AMENDATORY DESIGN SERVICES AGREEMENT

**SCOPE OF WORK
CITY & COUNTY OF DENVER – DEPARTMENT OF TRANSPORTATION & INFRASTRUCTURE
HSIP FY 2024 COLORADO BLVD & ALAMEDA AVE
CHANGE ORDER 1**

March 1, 2024

Approximate SUE Investigation Limits

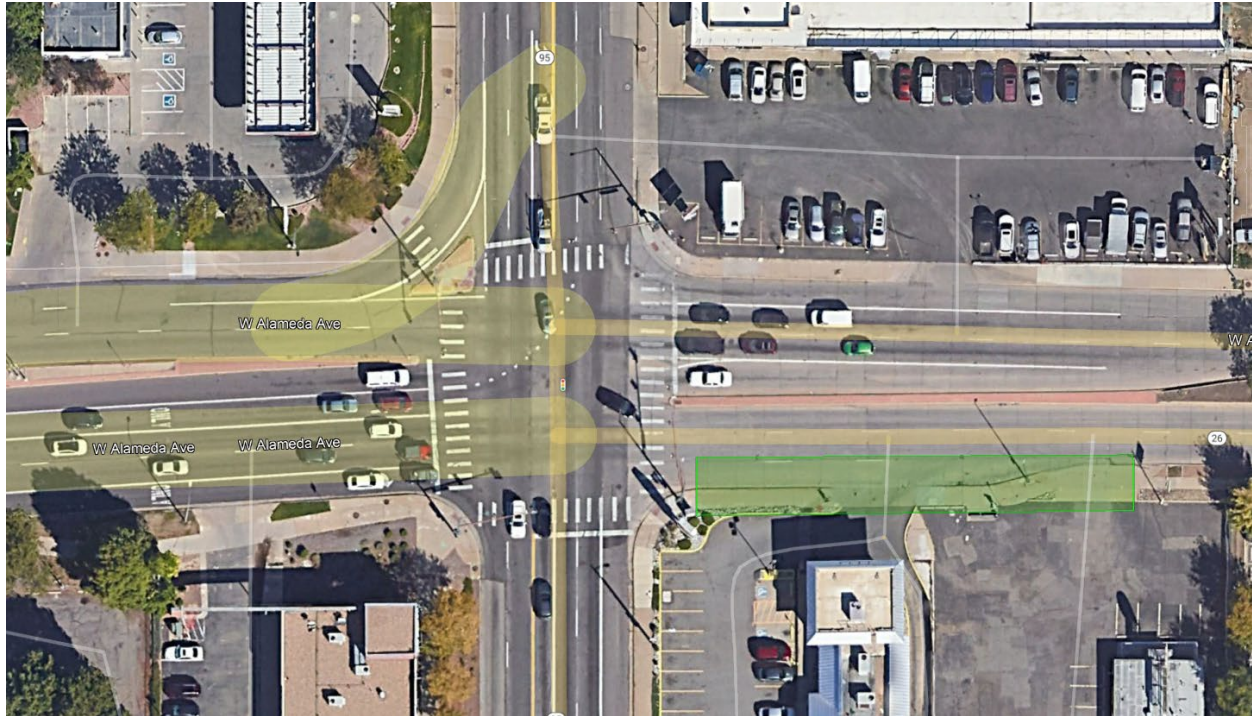
This change order extends the limits of the SUE investigation on the southeast corner of the Sheridan and Alameda intersection. Consort shall complete additional SUE investigation and prepare stamped SUE plans for the area identified :

One additional day of utility test holes has been assumed and shall be coordinated with the City and County of Denver before proceeding.
